AQ Matic Valve & Controls Company, Inc.

## PERFORMANCE BULLETIN 109

### V425 Lower Diaphragm Plate Change for Spring Assist Open Valves

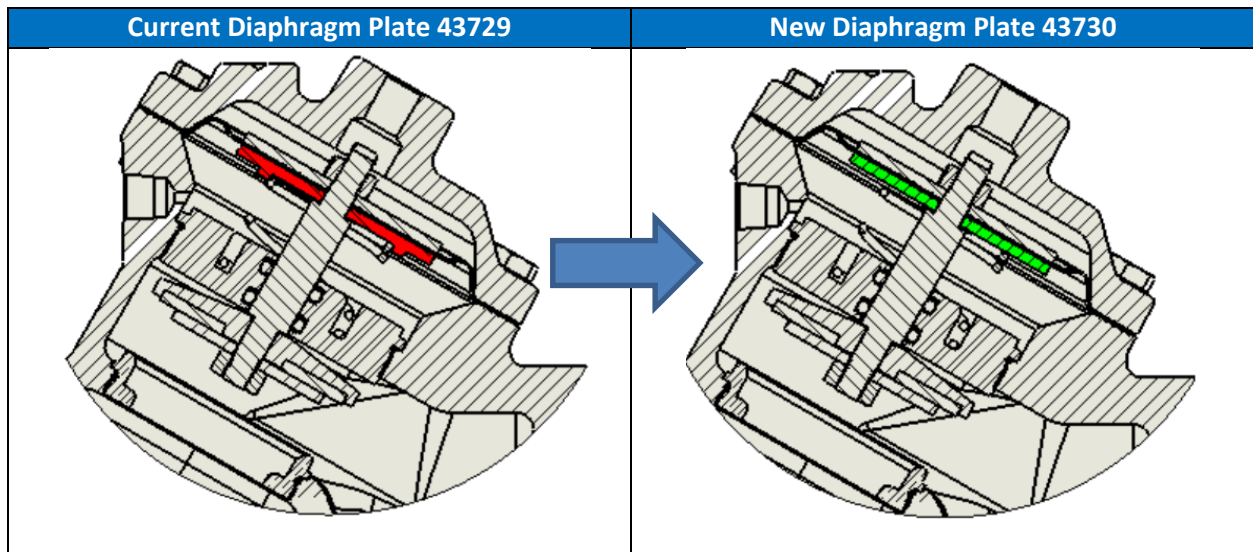
Lower Diaphragm Plate PN 43729 is being obsoleted and replaced with PN 43730. Plate 43729 was used only on Spring Assist Open V425 valves. PN 43730 is the current Diaphragm Plate used on all other configurations. It was determined the special plate 43729 which had a centering ring is not required because the spring is centered by the shaft guide and retained in application under spring compression.
